Re: TED-2008-185 Cemetery Ridge

Transportation Engineering Design Standards (TEDS) Exception Approval / Denial Form

Name: Cemetery Ridge Sub.

Transportation Engineering Design Standards (TEDS) Exception Recommendation Form

CEMETERY RIDGE
 COMPOSITE PLAN

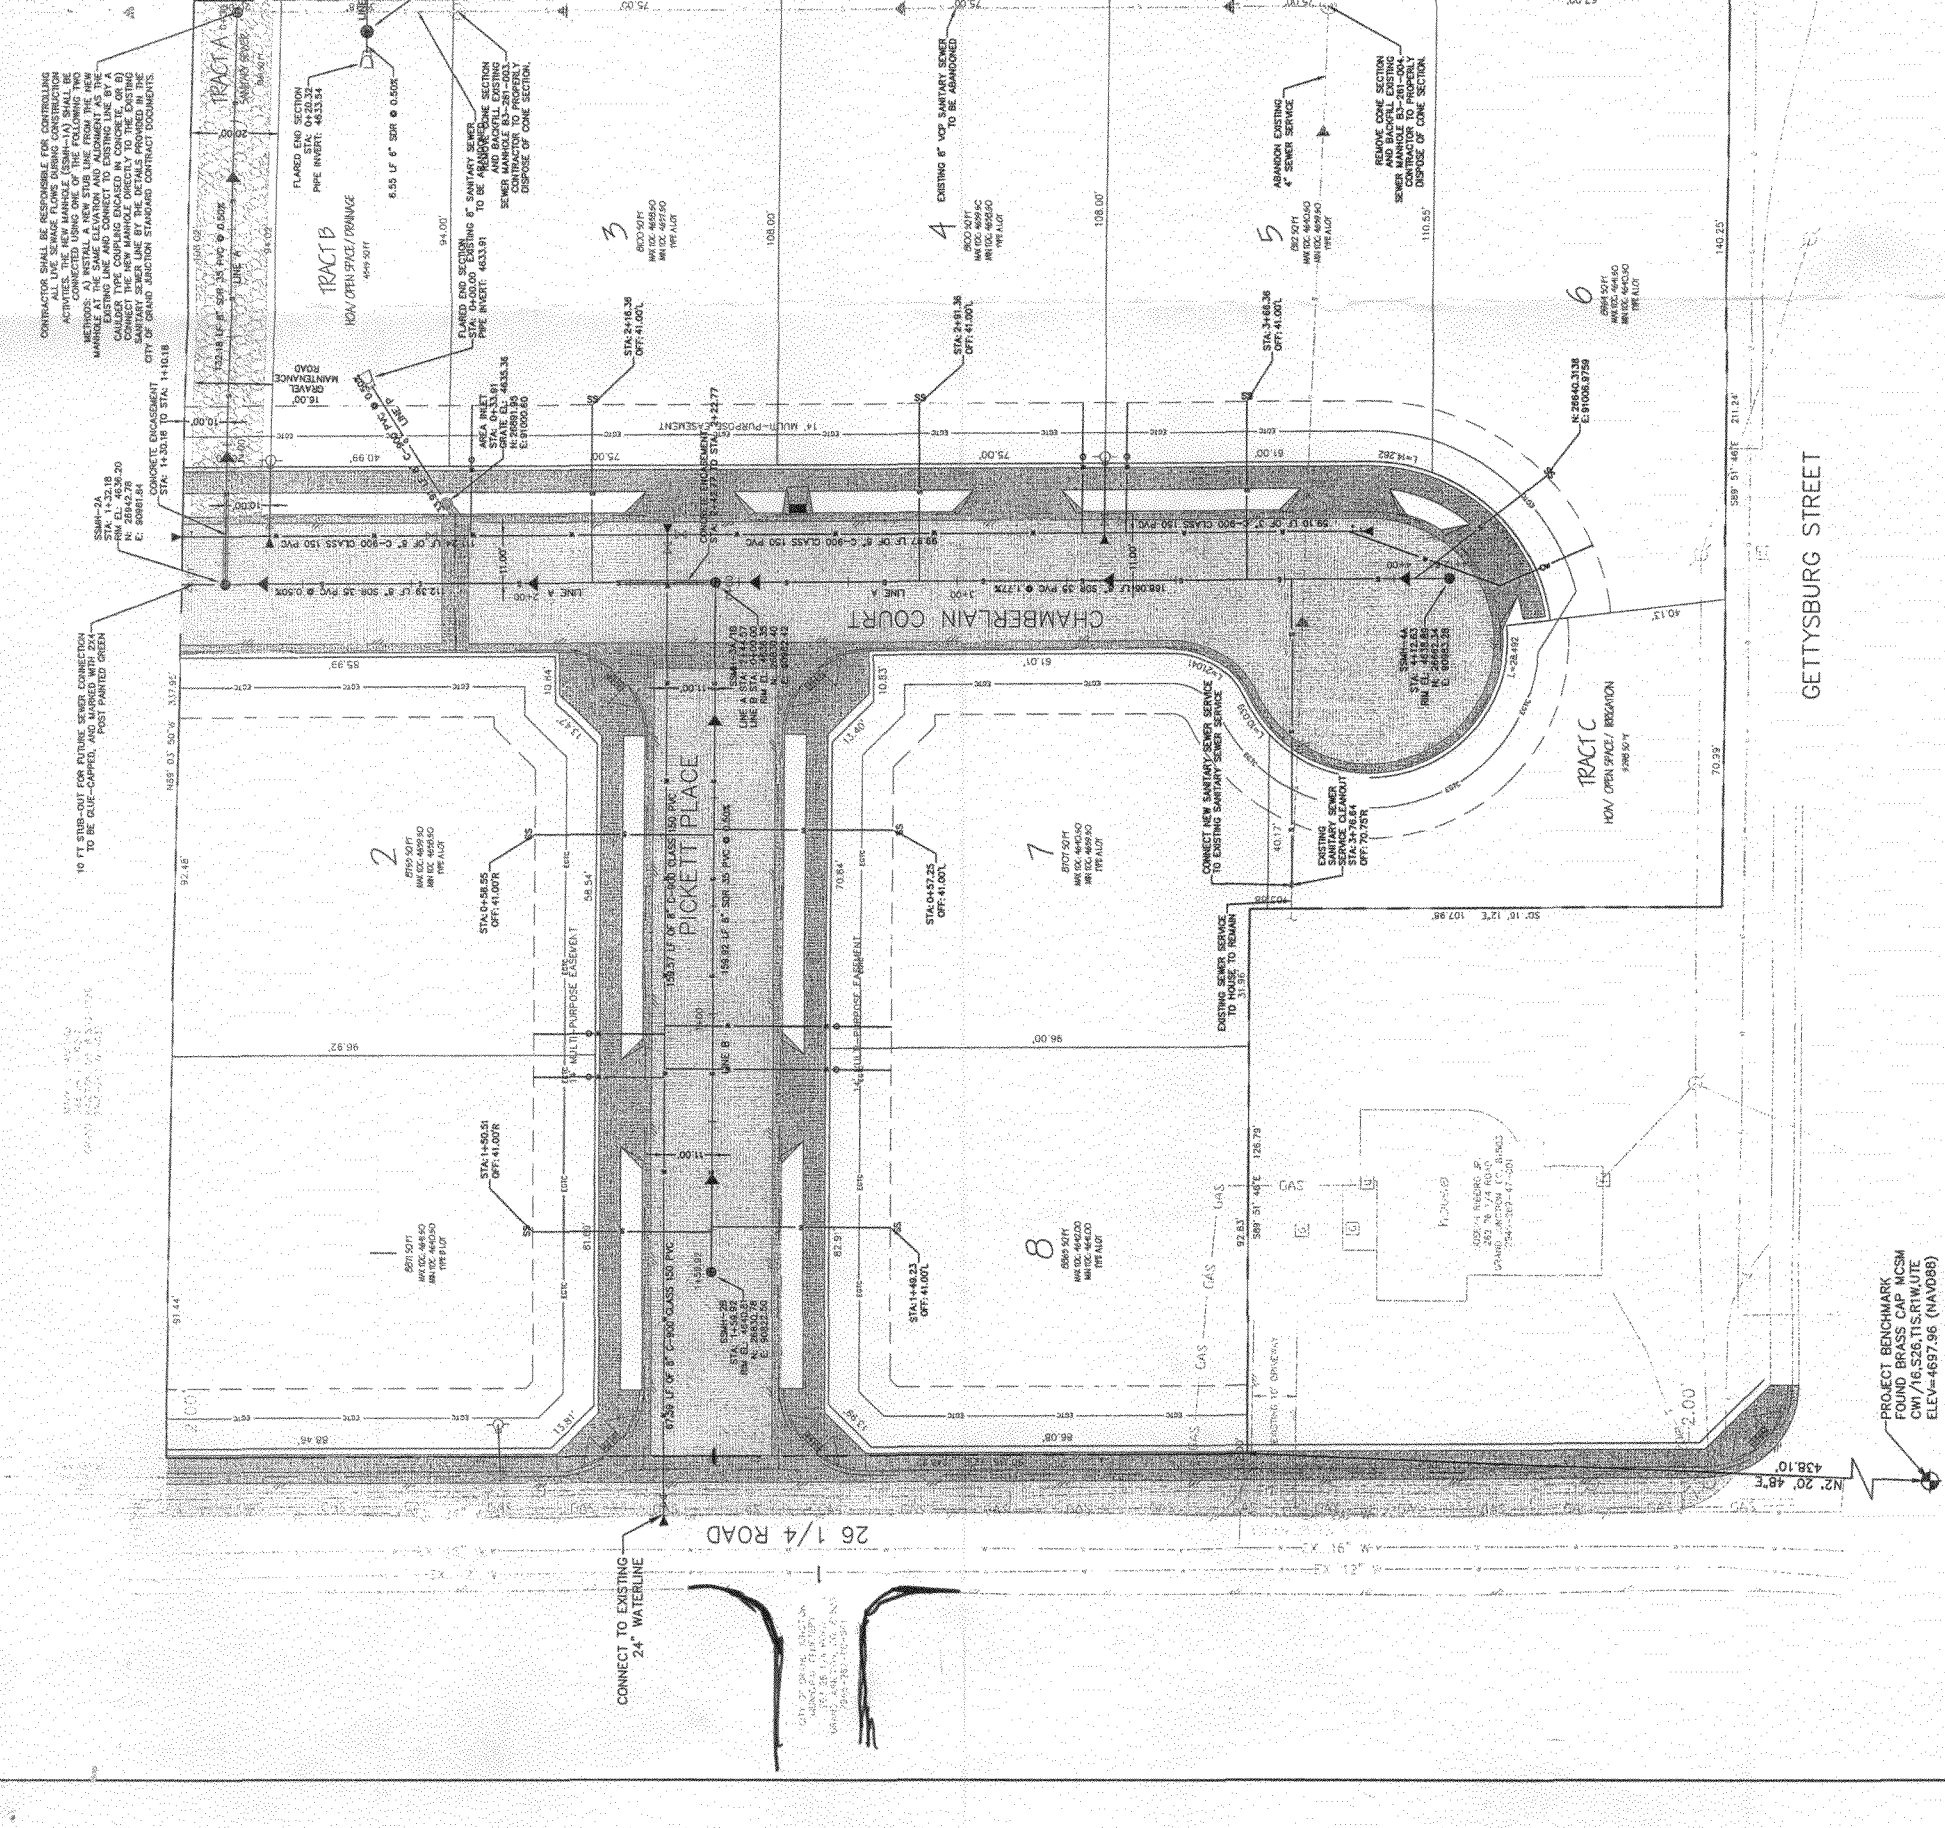
Comment: The applicant proposes to align a subdivision access intersection approximately 40' north (measured to centerlines) of an existing public cemetery entrance on 26¼ Road. The applicant correctly indicates that this is a very slight deviation from offset requirements, and that the cemetery access in question has extremely low usage.

It is possible to make the intersection align with the existing access, but this would result in an awkward street layout within the subdivision, and would not increase traffic safety to any appreciable degree.

A. Description: *The proposed Cemetery Ridge Subdivision is located on the east side of 26 ¼ Road. Adjacent to the project on the west side of 26 ¼ Road is a City of Grand Junction Cemetery. TEDS Section 4.1.2 Offsets states that access on opposite sides of the street be aligned, and if not aligned the minimum offset shall be 50 feet on local streets (26 ¼ Road is a local street). The cemetery has several existing access points, one of which is offset approximately 40 feet to the south of the proposed Cemetery Ridge Subdivision access point.*

1. How will the exception affect safety? *The requested exception is in regards to the alignment of the entrance (access) to the subdivision (Pickett Place) with an existing driveway. The existing driveway is to a section of the City Cemetery located on the west side of 26 ¼ Road. It is not anticipated this request would affect safety because the noted existing cemetery driveway is only used by maintenance personnel and people visiting very old graves. Funerals and newer graves are located north of the project and area accessed by other driveways. The proposed subdivision only contains eight lots. Give the amount of traffic generated by those lots and the amount of traffic using the cemetery driveway the likelihood of a traffic conflict is extremely low.*

2. Have other alternatives been considered that would meet the standard? *Yes, the proposed access point could be moved to align with the Cemetery driveway. However, this is not a desirable alternative because it would create unbuildable lots and an undesirable subdivision layout.*

Approved as requested.

Approve as requested.
